## Castle Street, Banbury

### Flood Risk & Drainage Technical Note

<b>Project No.</b>	1260
<b>Revision</b>	C (Changes Highlighted)
<b>Date</b>	01 April 2022
<b>Client</b>	Churchill Retirement Living
<b>Prepared</b>	L Blackmore
<b>Checked</b>	C Yalden
<b>Authorised</b>	C Yalden
<b>File Ref.</b>	P:\1260 Castle Street, Banbury\C Documents\Reports\1260 - Castle Street, Banbury - Flood Risk & Drainage Technical Note - C

- 1.2 This technical note has been revised to take account of Oxfordshire County Council's consultation response for this application (21/04202/F), specifically related to comments received from the Lead Local Flood Authority (LLFA) (dated 25 February 2022, see Appendix L). Revised content has been highlighted for ease of reference and a summarised response provided within the concluding section of this report.

## **Appendix I** Existing Impermeable Areas Plan

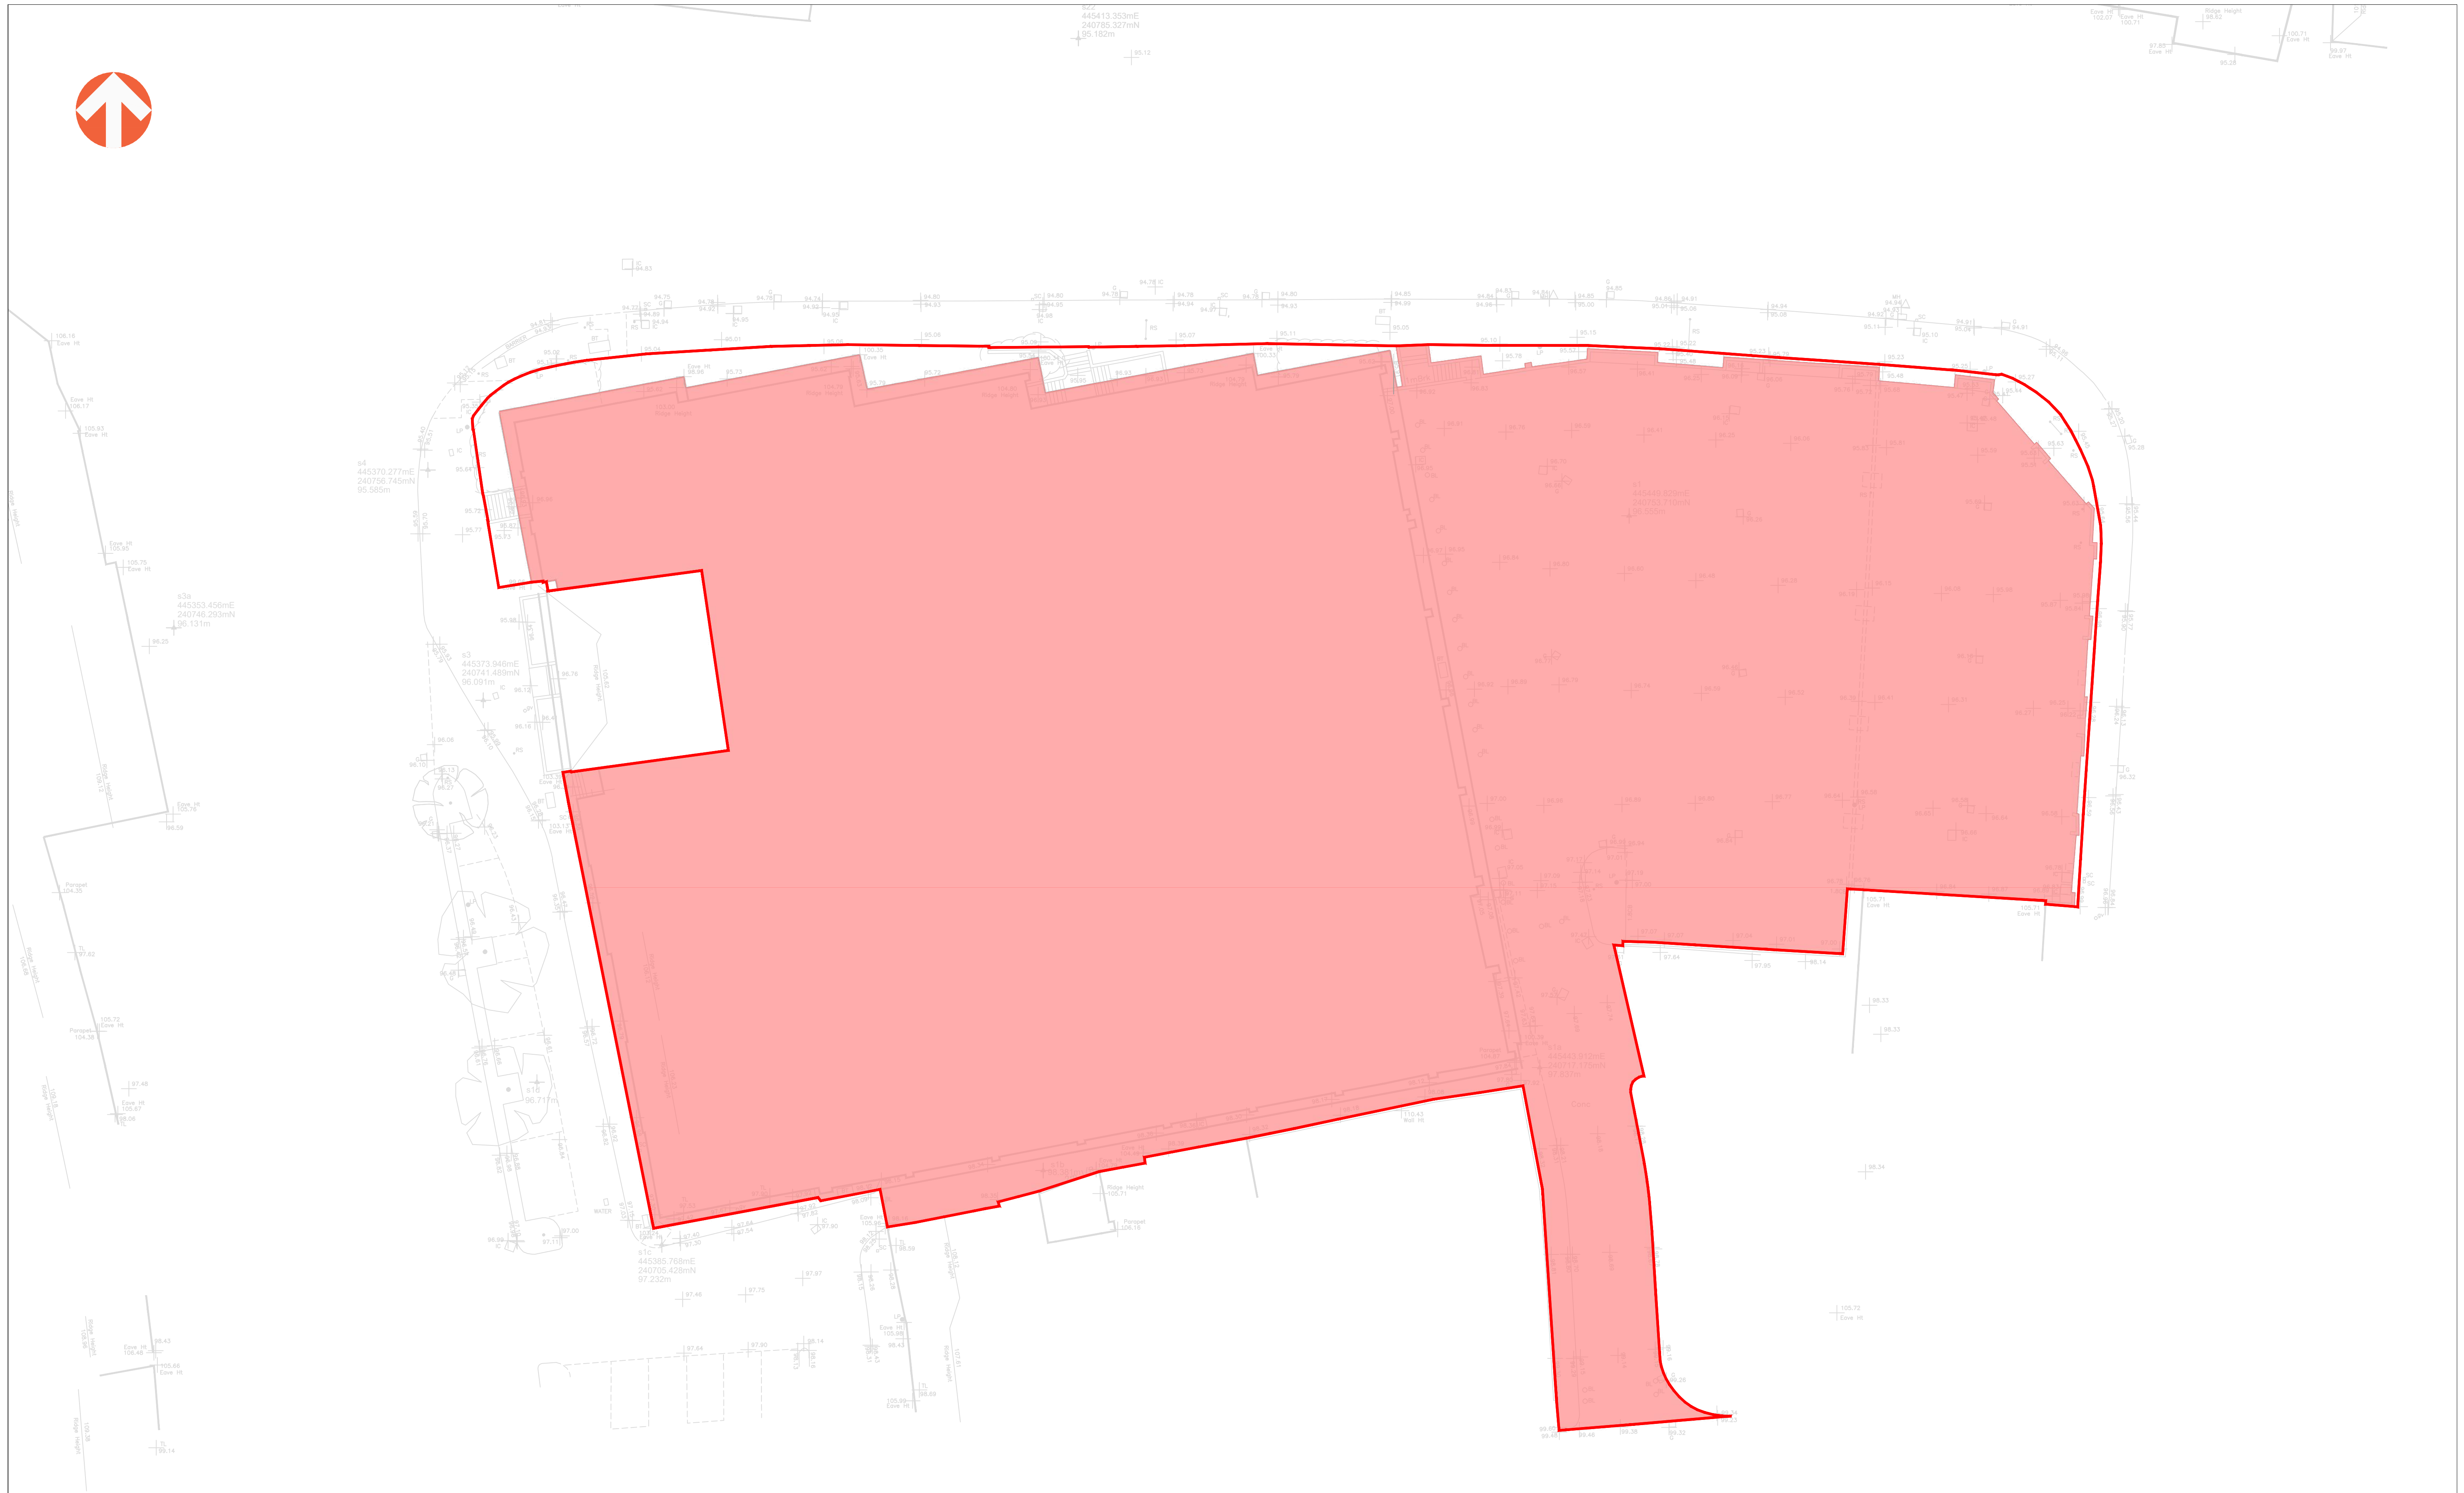
- 8.6 *Surface water catchment plan not provided.* An 'Existing Impermeable Area' plan has now been provided (Appendix I). The impermeable catchment areas for the proposed development are now indicated on the updated PDL (Appendix H).

Surface water catchment plan required to demonstrate how the site will drain and to which drainage features. The proposed areas needs to be clearly shown and the existing areas.

- 4.6 The proposed scheme identifies a significant amount more permeable green space than the existing site, reducing the drained catchment from 0.477ha to 0.308ha, offering a 35% reduction. An 'Existing Impermeable Areas' plan is provided in Appendix I.
